**LEBANON PLANNING BOARD
OCTOBER 10, 2022 - 6:30 PM
COUNCIL CHAMBERS, CITY HALL OR
REMOTE VIA VIRTUAL PLATFORM
LEBANONNH.GOV/LIVE**

- C. *REVISED* - LWM Residential LLC, 1 Foundry Street (Tax Map 91, Lot 263), 25 Mechanic Street (Tax Map 91, Lot 267), and 43 Mechanic Street (Tax Map 106, Lot 34), zoned LD:** Request for Site Plan Review of a phased, 196-unit multi-family development including a new 4-story, 27-unit multi-family building with a parking garage on the ground floor at 43 Mechanic Street; a new 4-story, 31-unit multi-family building with a lower-level parking garage at 25 Mechanic Street, to be merged with 1 Foundry Street; and, at 1 Foundry Street, the renovation of the existing Woolen Mill building into 49 dwelling units, the renovation of the existing commercial building and boiler building into amenity spaces, construction of a 2-story parking structure, and construction of a new 5-story, 89-unit multi-family building with a lower-level parking garage, together with associated site improvements. Applicant also requests a Conditional Use Permit pursuant to Section 307.8.A to allow an increase in the maximum permitted building height. PB2022-36-SPR - Continued from S

Plotted By: Shanie Wong Sheet Set: NH-LWM PERMIT SET Layout: L303 Version: September 23, 2022 10:54:30am Stored: T:\NH-LWM\Lebanon Woolen Mill\NH-LWM\SHEETS\NH-LWM-L3 CONSTRUCTION DETAILS.dwg 5/18/2022 5:23:22 PM

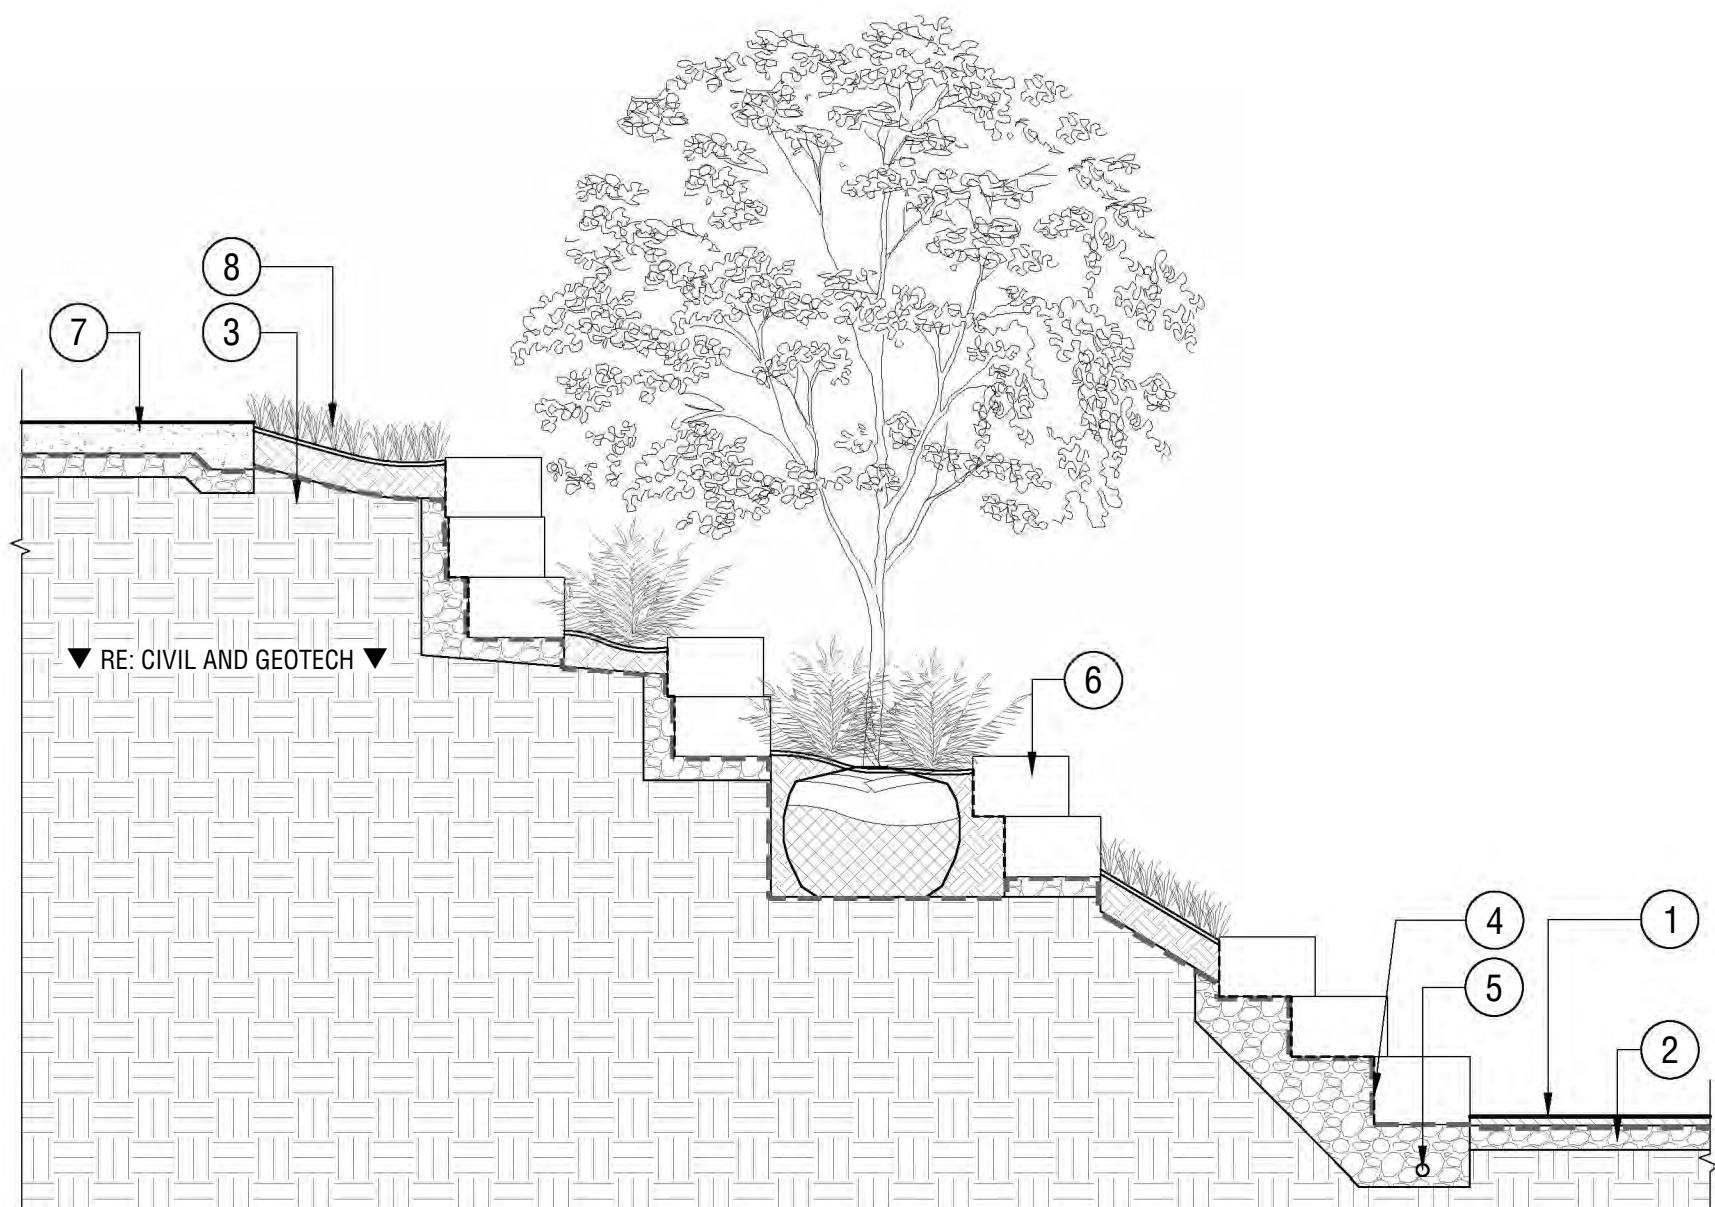
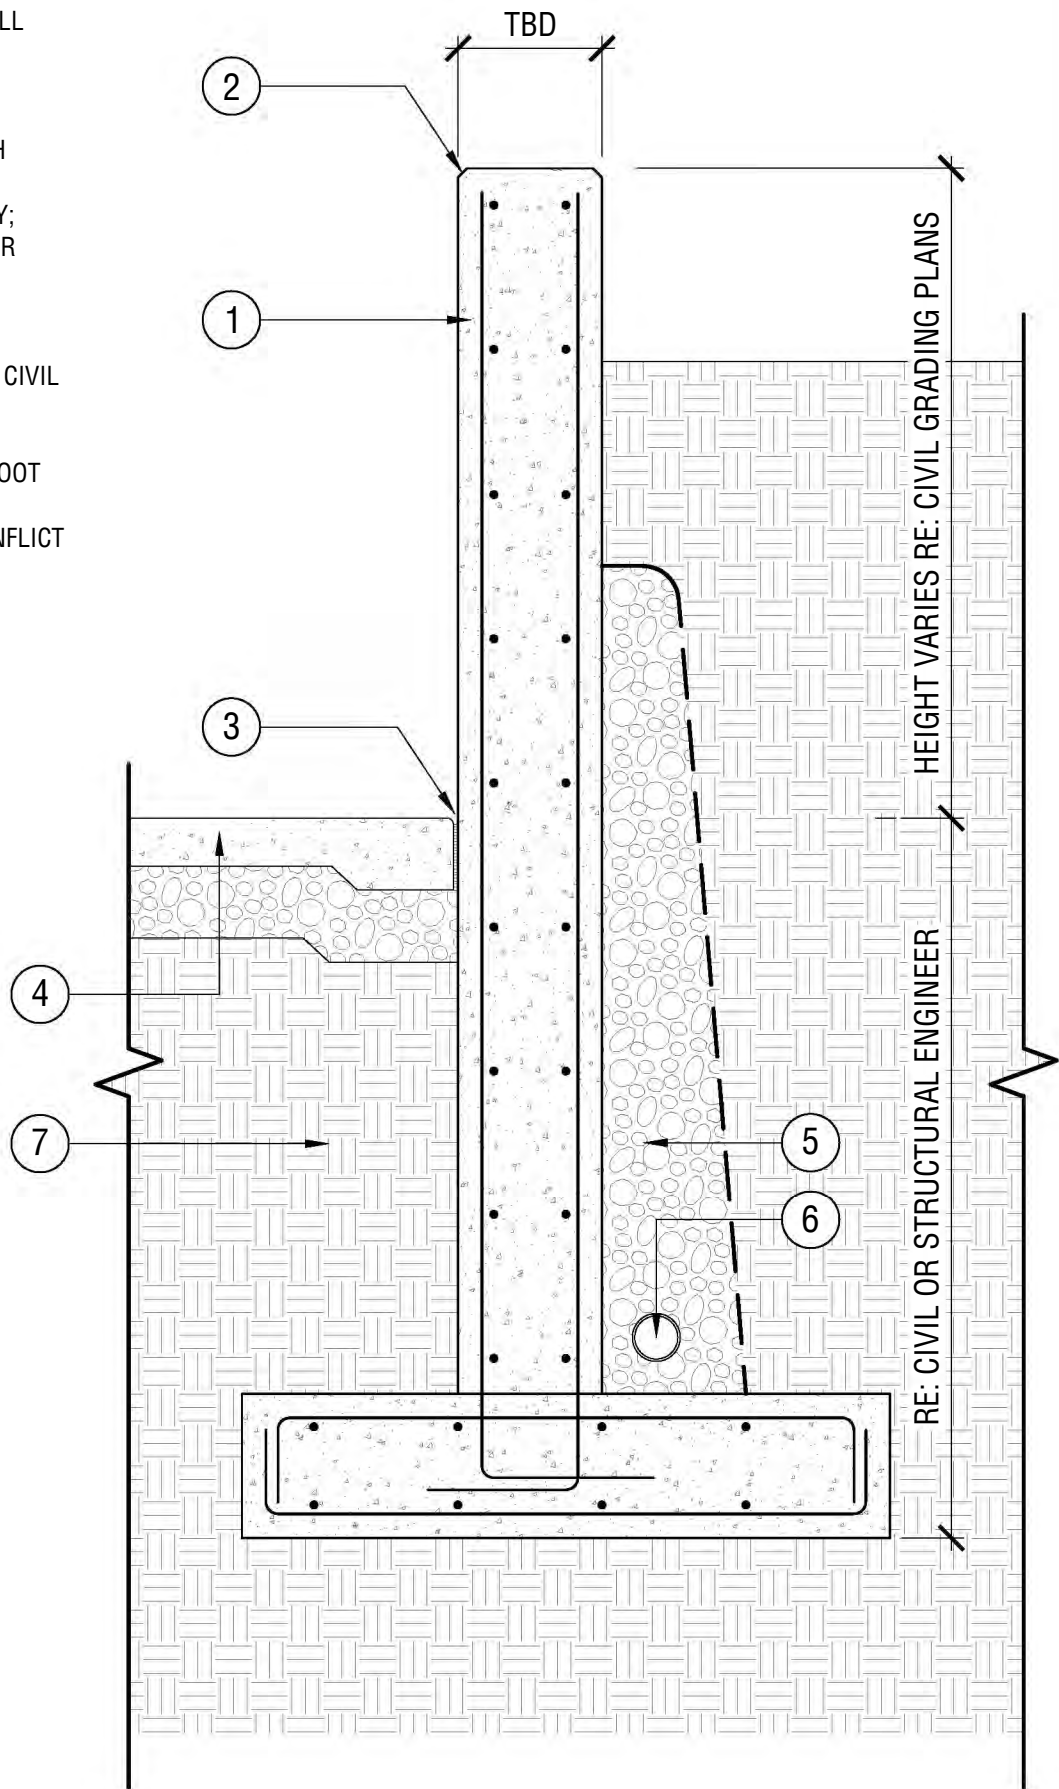
- The detail on sheet L303 be expanded to indicate how traffic and pedestrian safety will be maintained during construction.

- *OJB: It is proposed to be a stacked stone wall, with plantings integrated. Please refer to detail 02, 03 – L303.*

PLANTING SCHEDULE
AND NOTES

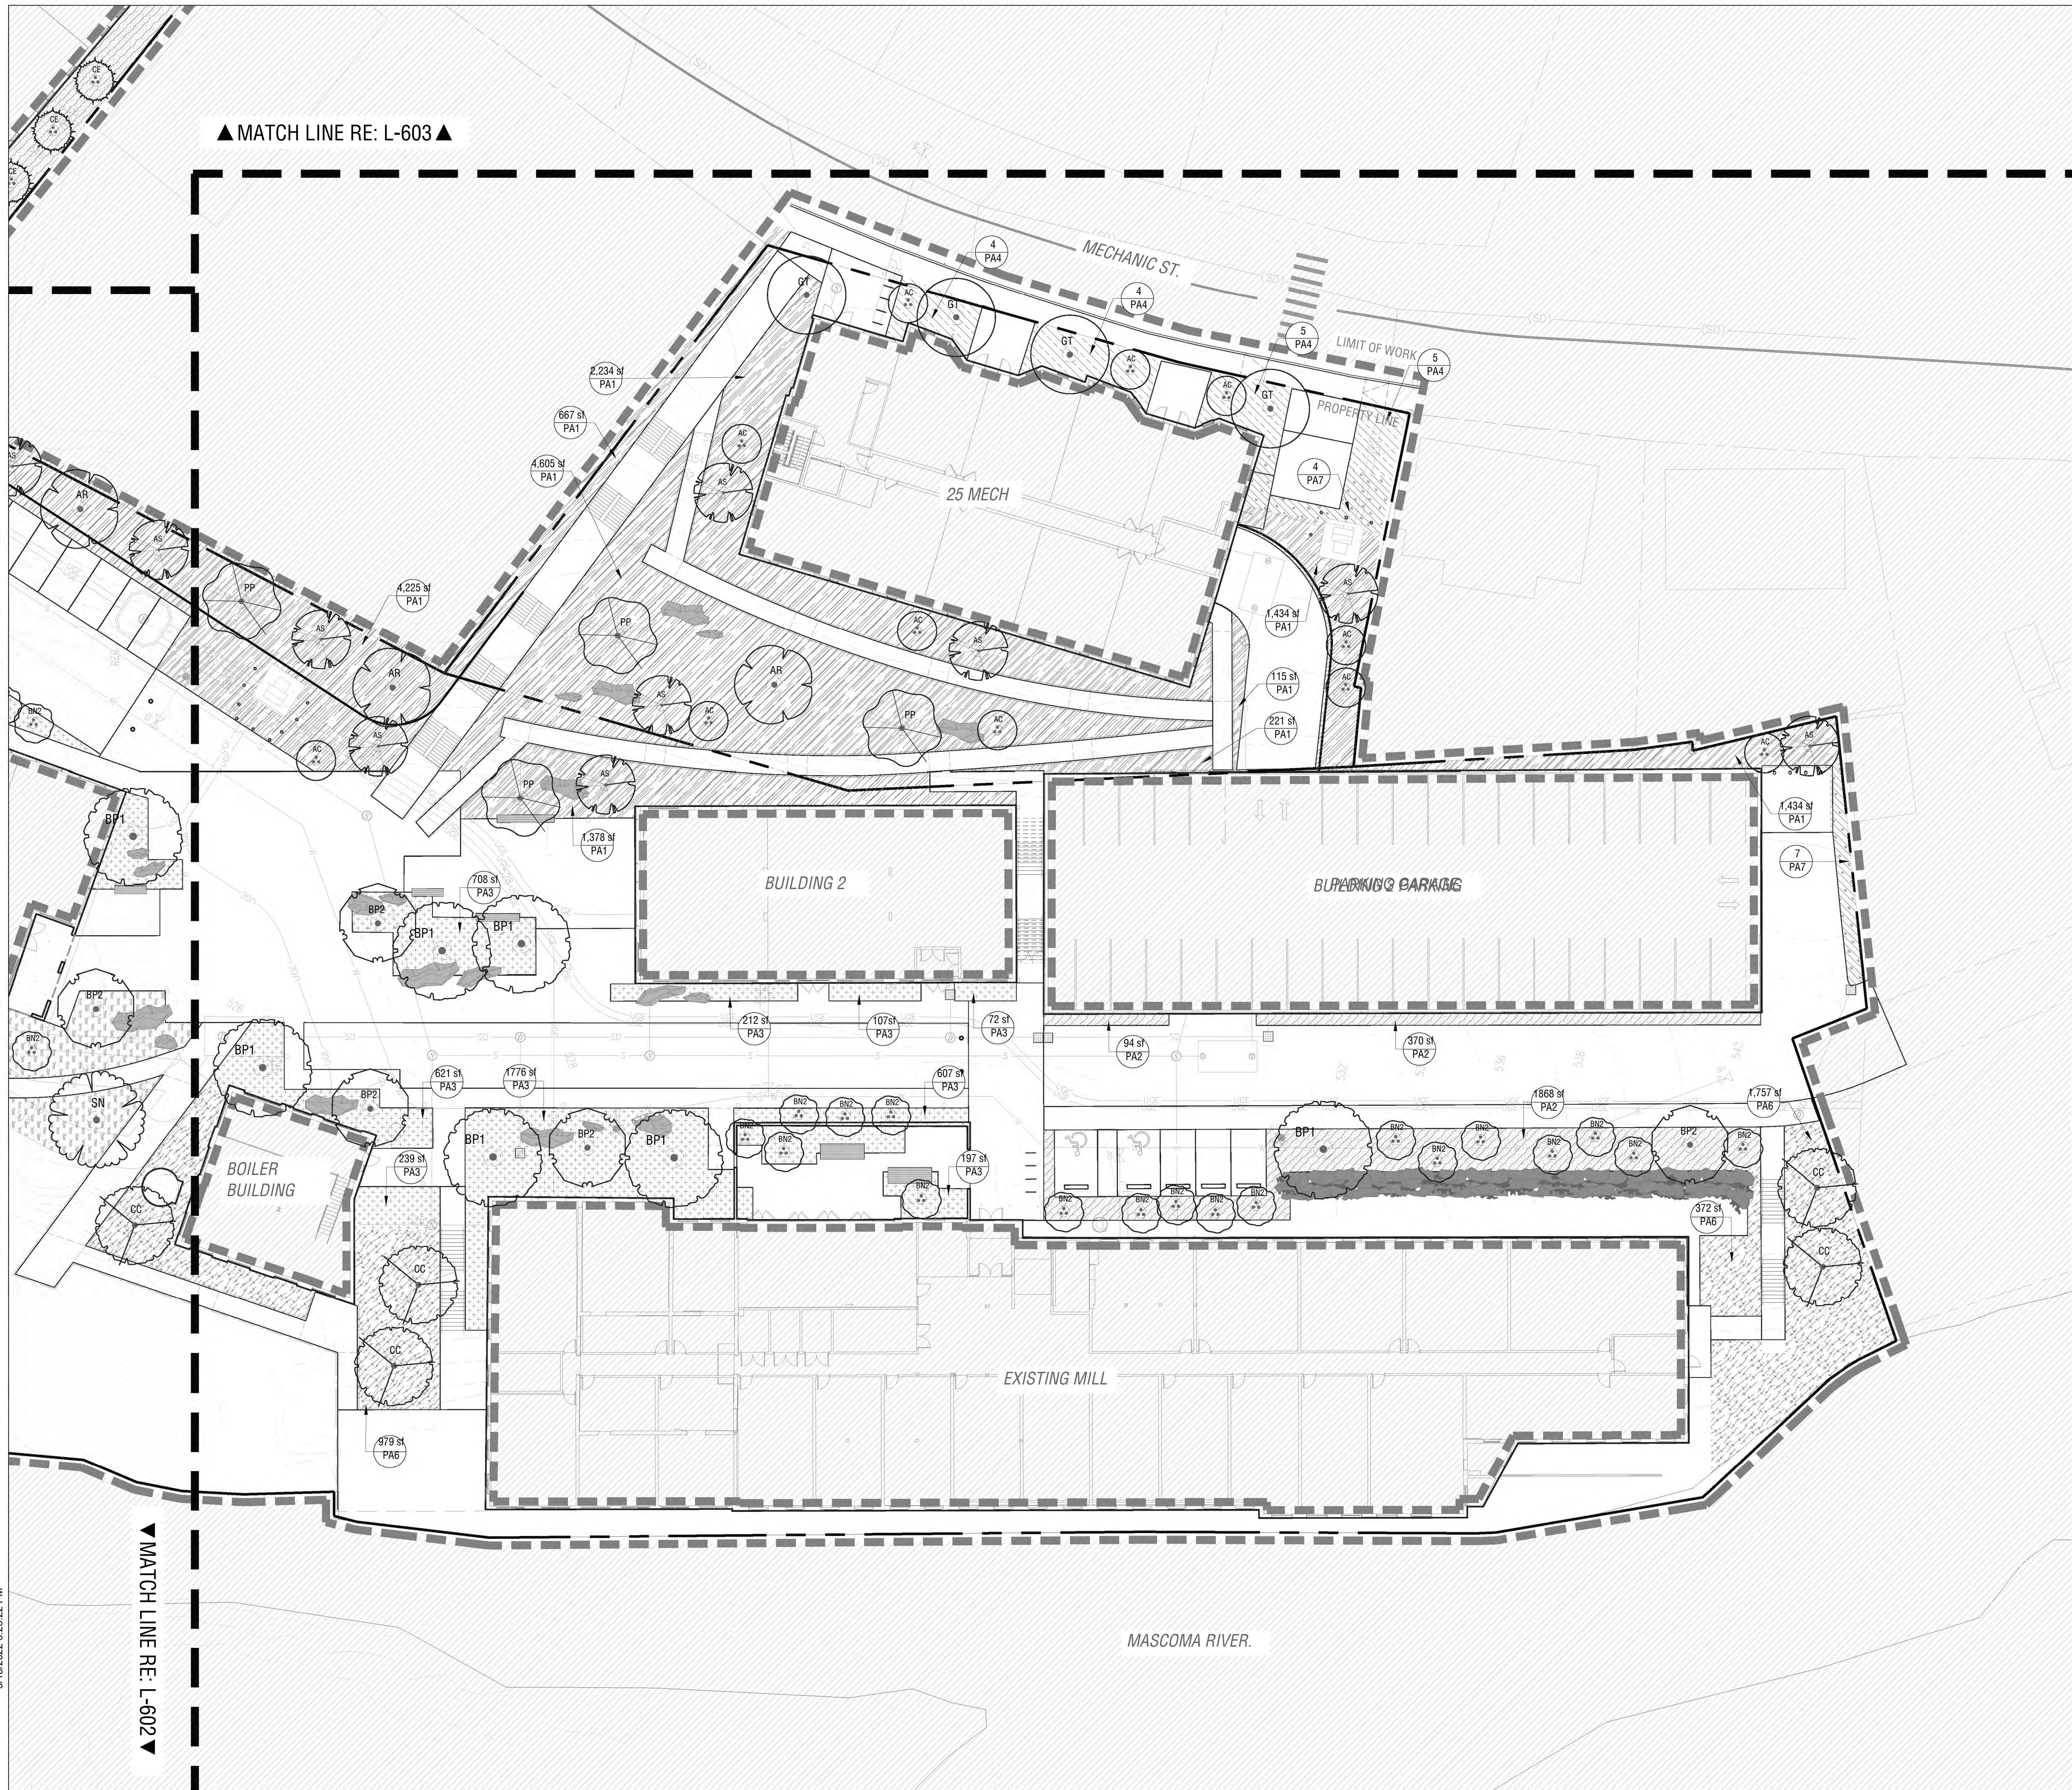
Sheet 41 (Planting Schedule and Notes)

- *OJB: Tree counts are included in the schedule on sheet L600.*
